## Devlin Property

Re: Schematic Development Plan  
Devlin Property- 11506 Game Preserve Road  
RCI Job No. 1137B

Provided below are the responses to your comments dated May 28, 2014. The aforementioned comments are attached with this letter.

SDP-4560-2014

**SCHEMATIC DEVELOPMENT PLAN**

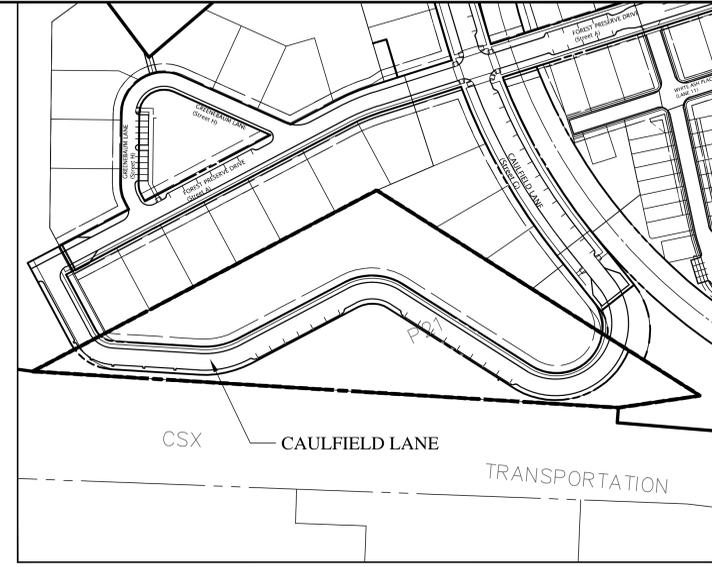
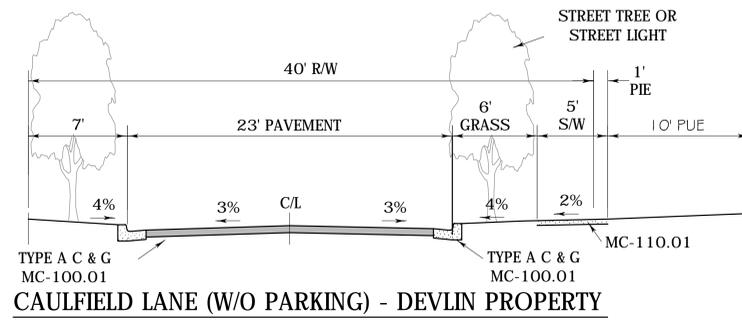
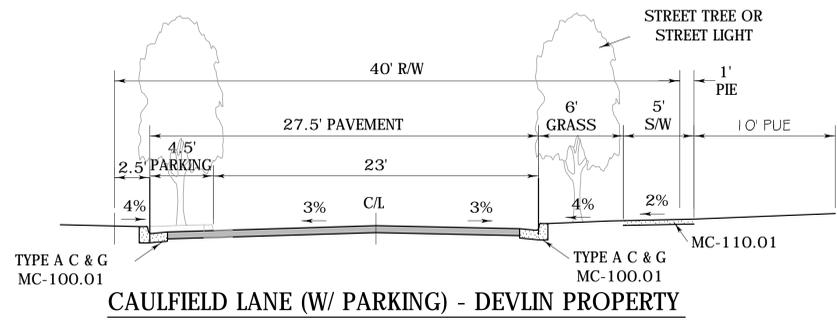
3. Show typical rear yard condition with deck and storm water management facility.

**A typical lot layout depicting the rear yard condition with deck and storm water management facility is included in the SDP, sheet 2.**

**ROAD DETAILS & ROAD CODE WAIVER EXHIBIT**

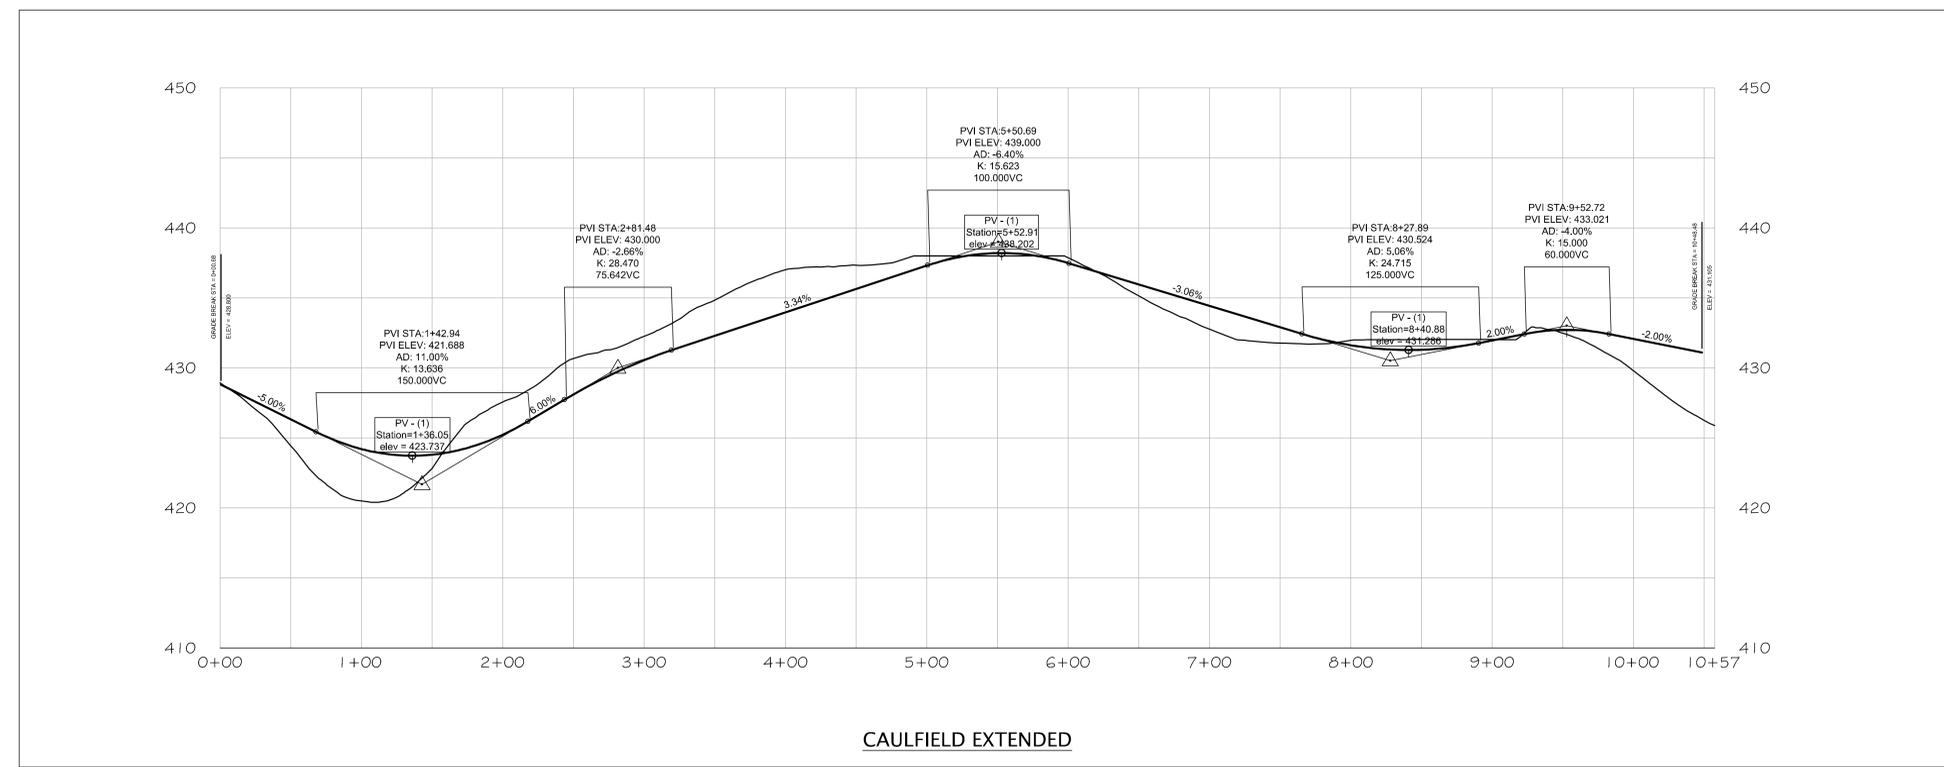
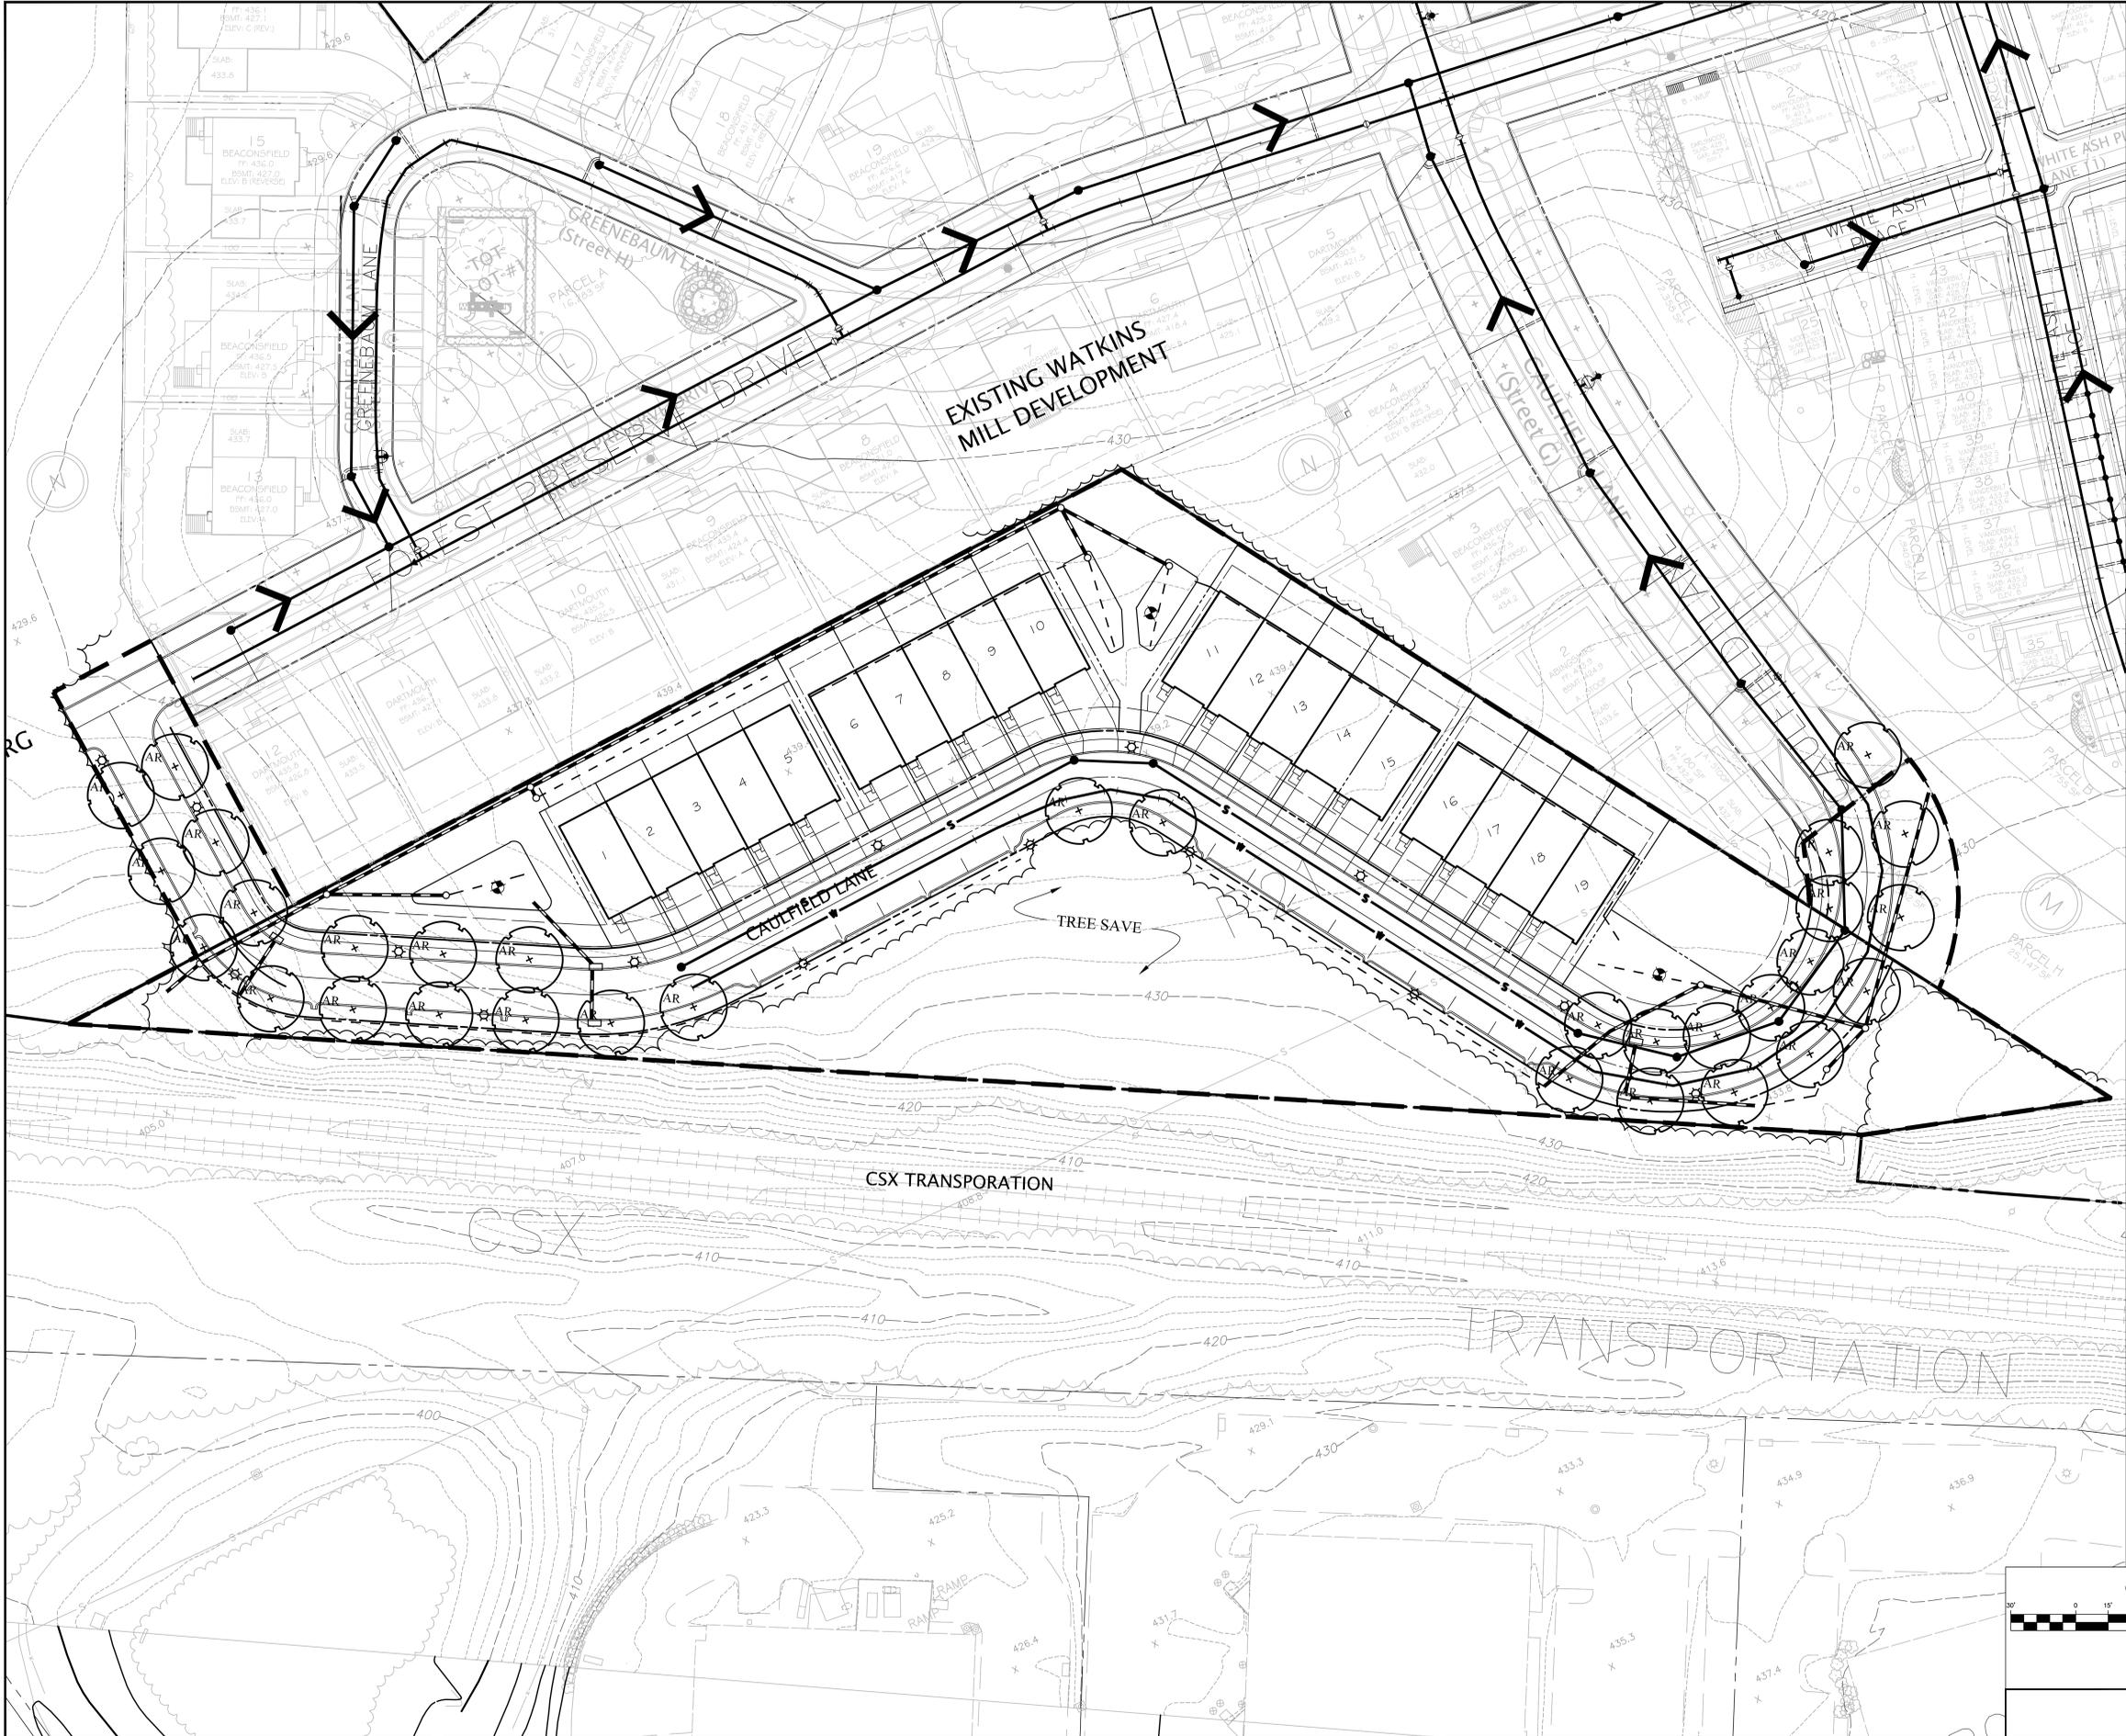
2a. Full width bulb-outs on new portion of Caulfield Lane should match partial width bulb-outs on approved section. Not done may impact green space calculations

**Parking on the new section of Caulfield lane has been changed from full width bulb-outs to partial width bulb-outs to match the previously approved section of Caulfield Lane. The road was previously 20 feet wide, with 7 feet of parking, now, with the partial width bulb-outs, the road is 23 feet wide, with 4.5 feet of parking.**

**LANDSCAPE AND LIGHTING PLAN**

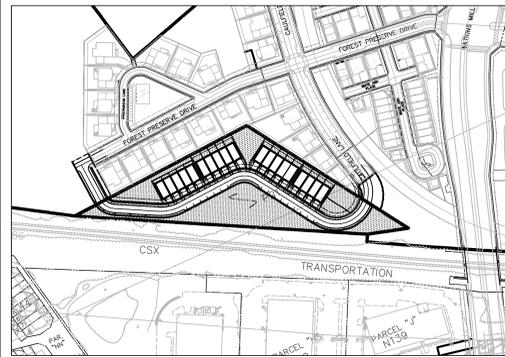
9. Provide green space diagram. Must have a minimal of 40% green space.  
**A green space diagram is provided on the landscape plan sheet, included in the SDP. 61% of green space is provided.**

4a. Street tree type needs to be called out – this relates to 2.c. above

**Street tree type is called out on the landscape plan of the SDP. A plant schedule is included as well.**

**PRELIMINARY FOREST CONSERVATION PLAN**

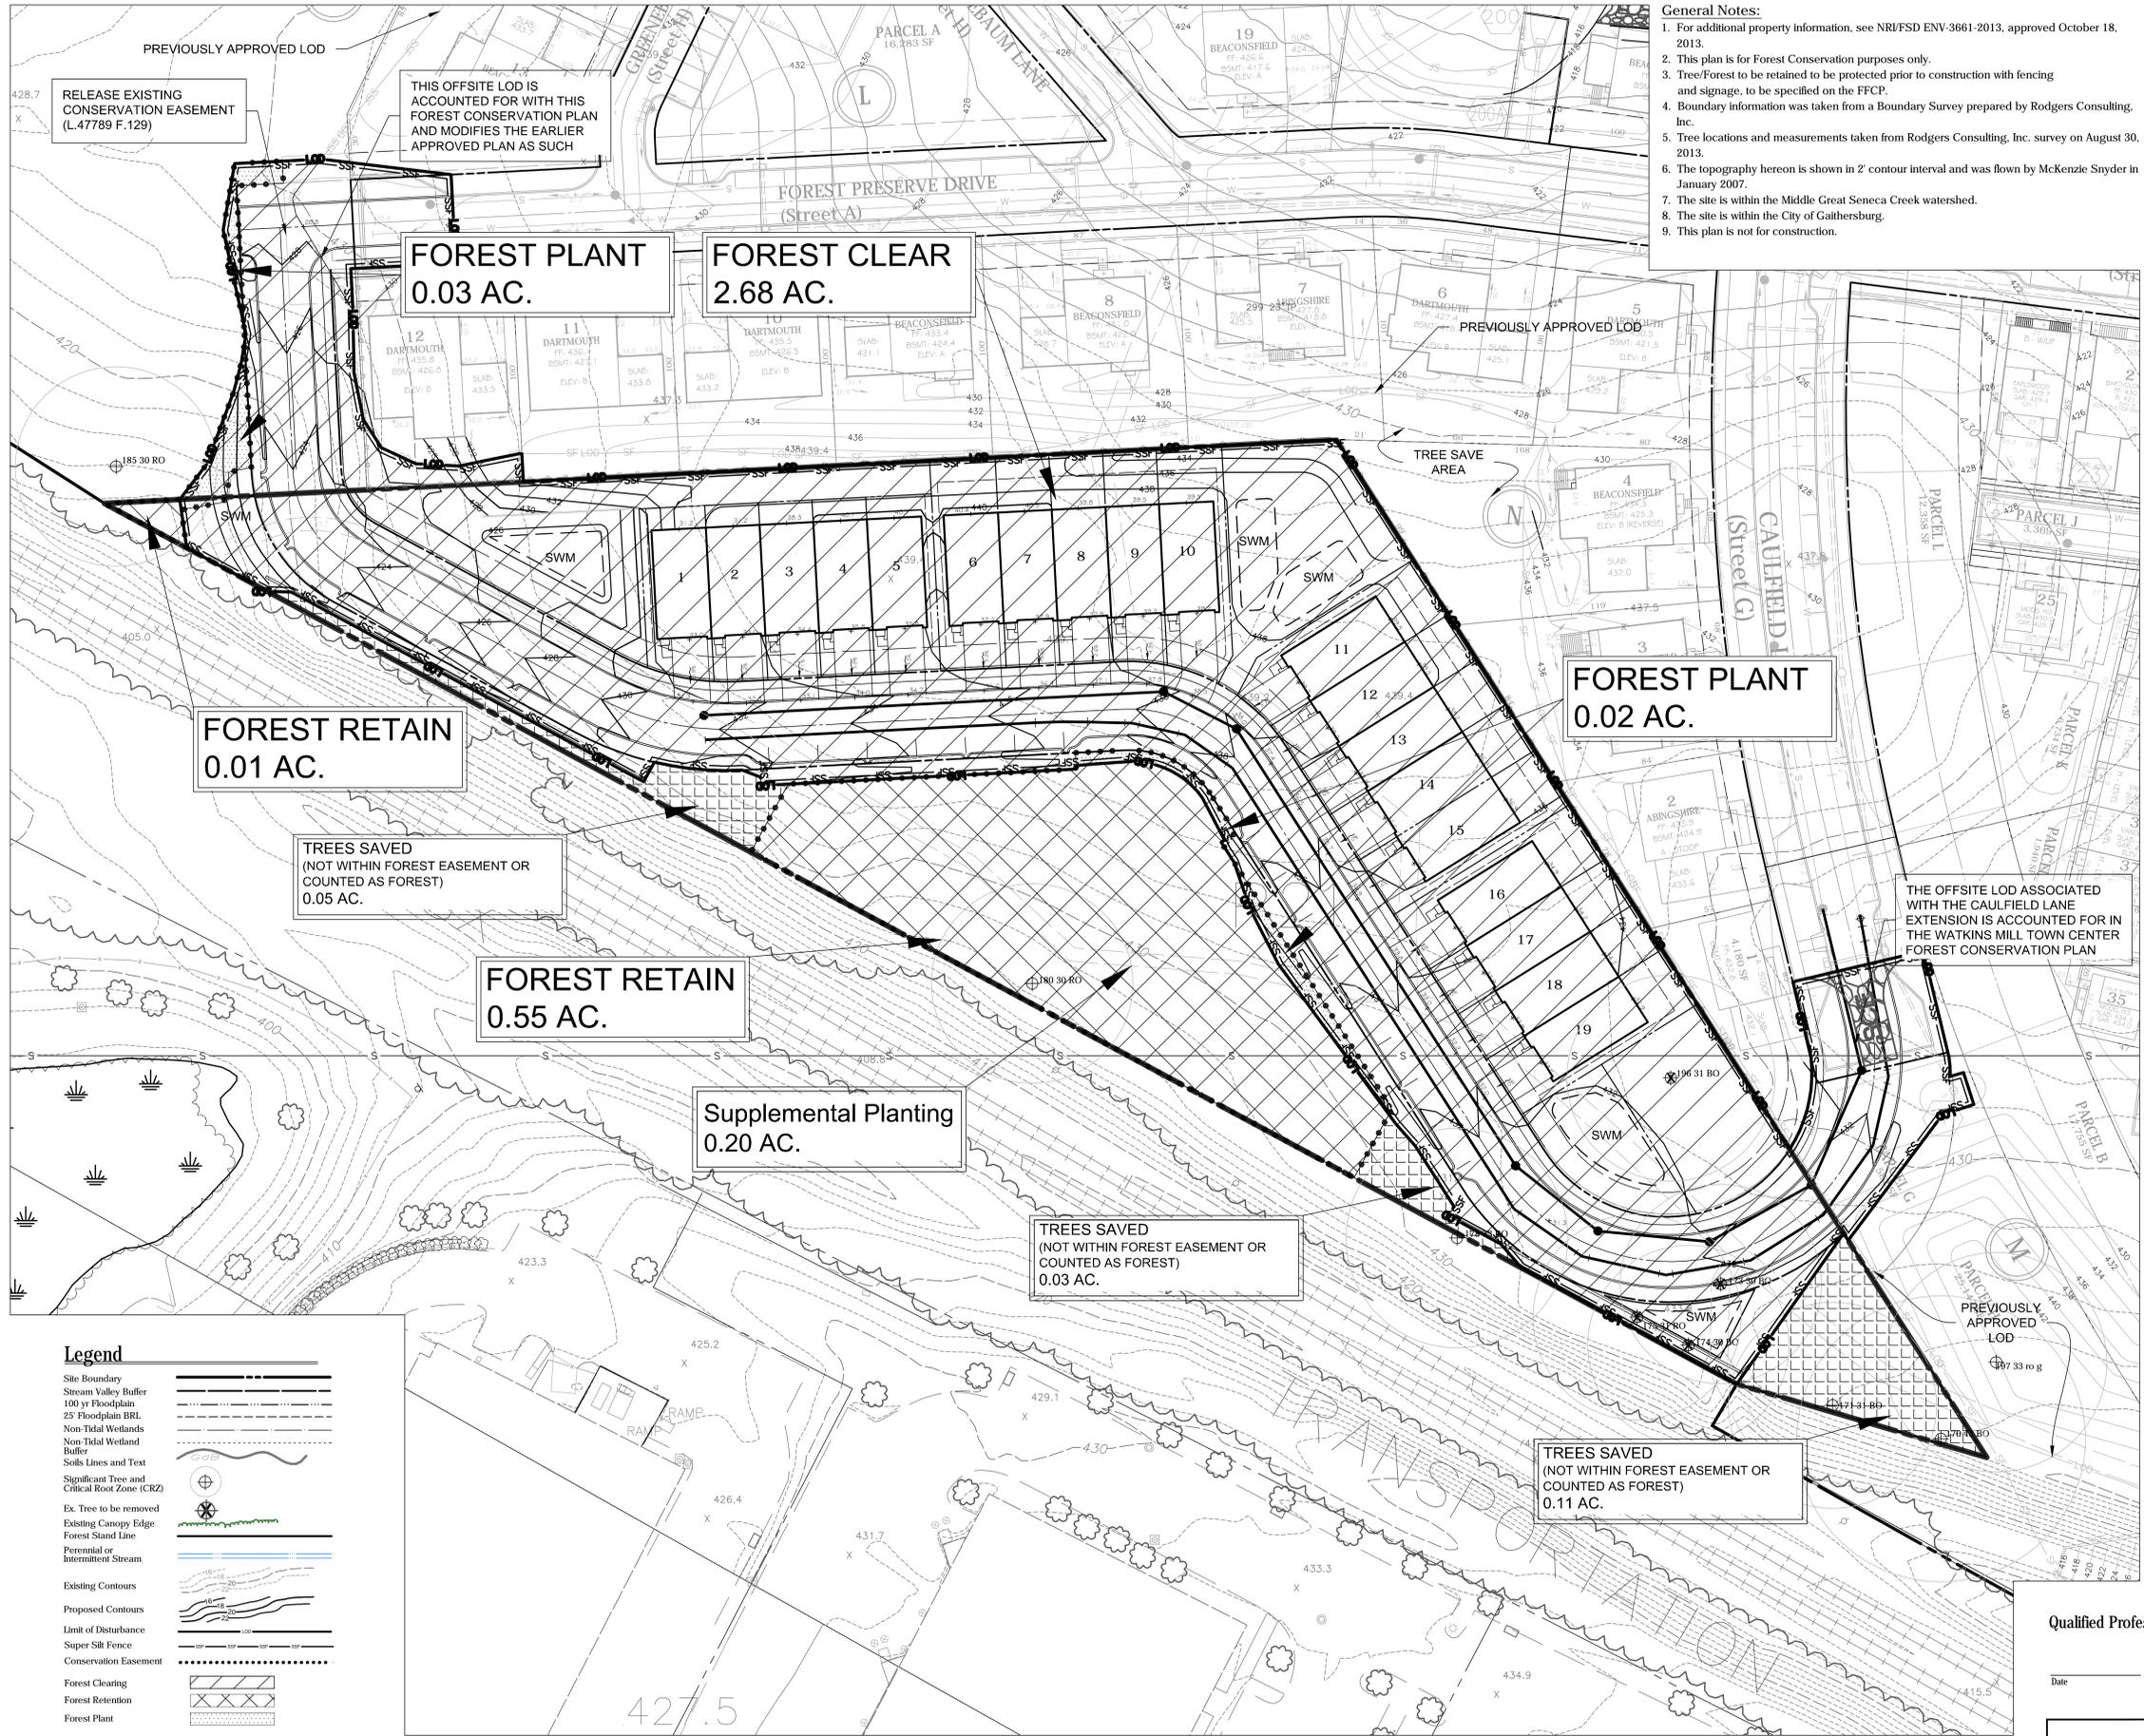
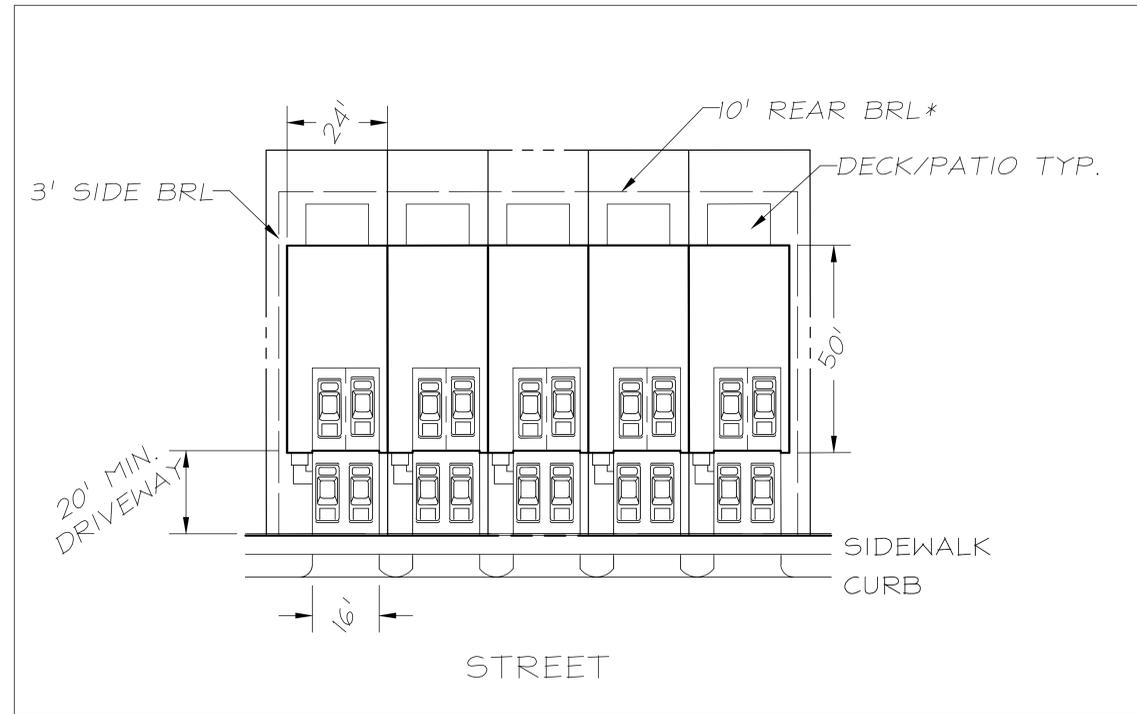
2. Supply detail regarding the 0.05 acre combined proposed reforestation areas. Those areas are tree save areas not being counted as forest. To avoid confusion the labels have been changed to read **Tree Saved (Not within forest easement or counted as forest)**.

3. On the FCP worksheet, call out the 2.12 acre tract area as net tract area. **So noted.**
